City of Portland, Maine – Building or Use Permit Application 389 Congress Street, 04101, Tel: (207) 874-8703, FAX: 874-8716

| Proposed Project Description: Shed dormer and bathroom on second floor | | | | PEDESTRIAN ACTIVITIES DISTRICT (P.A.D.) Action: Approved <input type="checkbox"/> Approved with Conditions: <input type="checkbox"/> Denied: <input type="checkbox"/> Signature: _____ Date: _____ | | Zoning Approval: Special Zone or Reviews: <input type="checkbox"/> Shoreland <input type="checkbox"/> Wetland <input type="checkbox"/> Flood Zone <input type="checkbox"/> Subdivision <input type="checkbox"/> Site Plan maj <input type="checkbox"/> minor <input type="checkbox"/> mm | |

BUILDING PERMIT REPORT

DATE: 6 Dec 99 ADDRESS: 35 Concord St. CBL: 130-H-010
 REASON FOR PERMIT: To Construct a shed dormer & bathroom
 BUILDING OWNER: Matilda Love
 PERMIT APPLICANT: _____ CONTRACTOR: John Murtan
 USE GROUP: A-3 CONSTRUCTION TYPE: 5B CONSTRUCTION COST: \$14000.00 PERMIT FEES: \$108.00

PLOT PLAN:

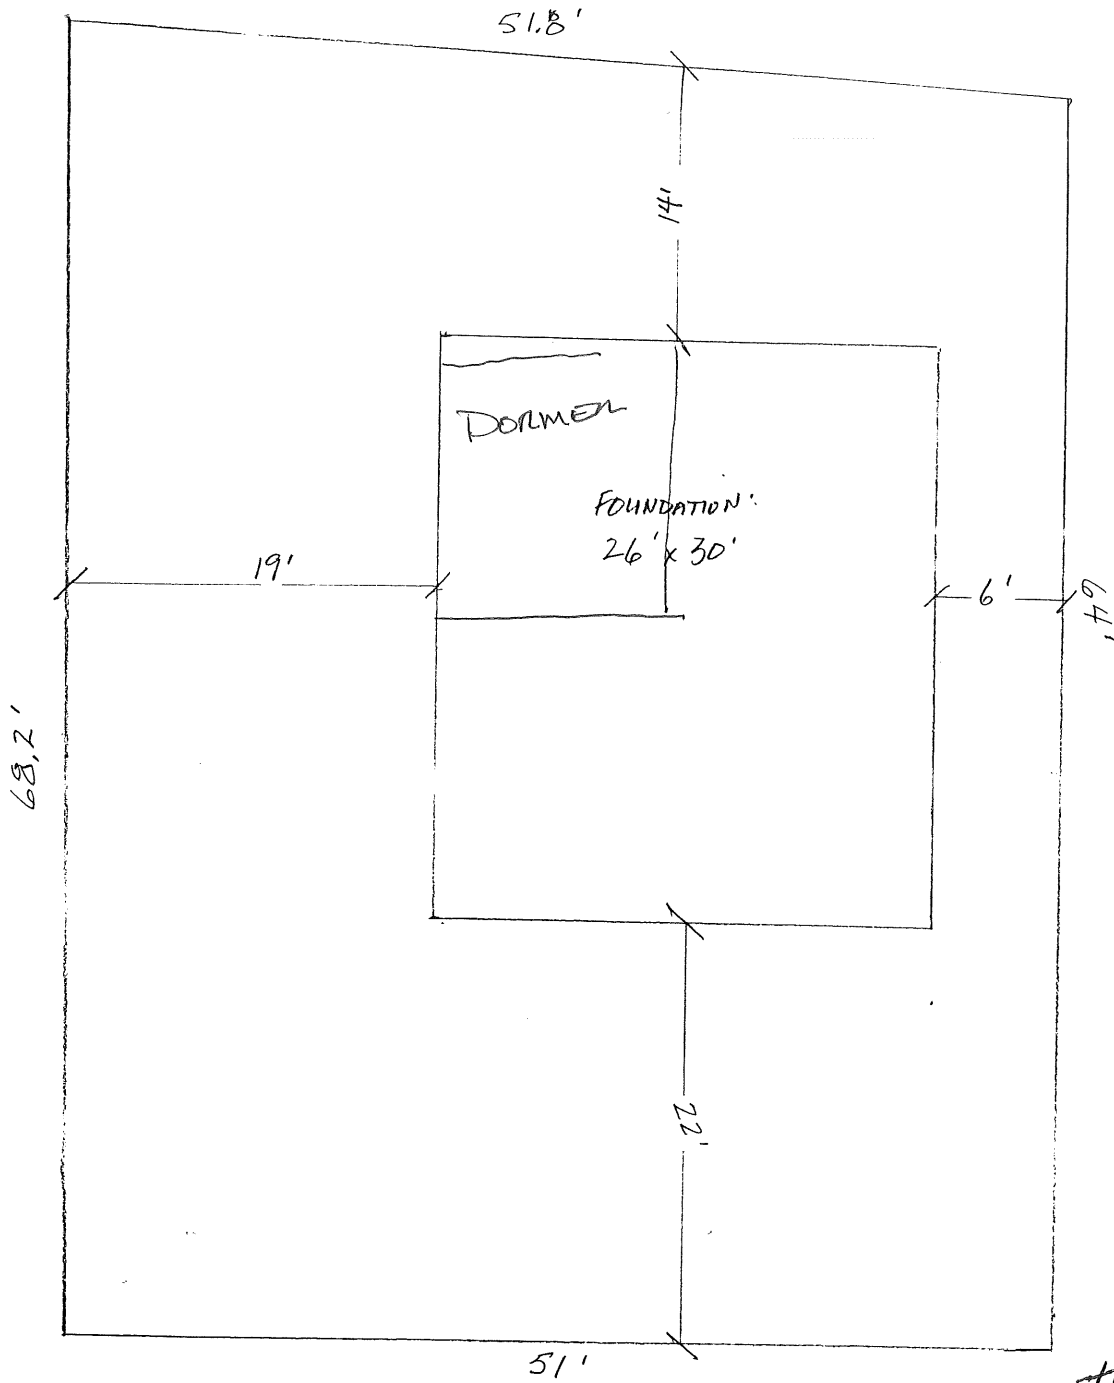
using Sec. 14-436⁽⁹⁾

AS long AS Not increasing original
foot print - setback ok to remain
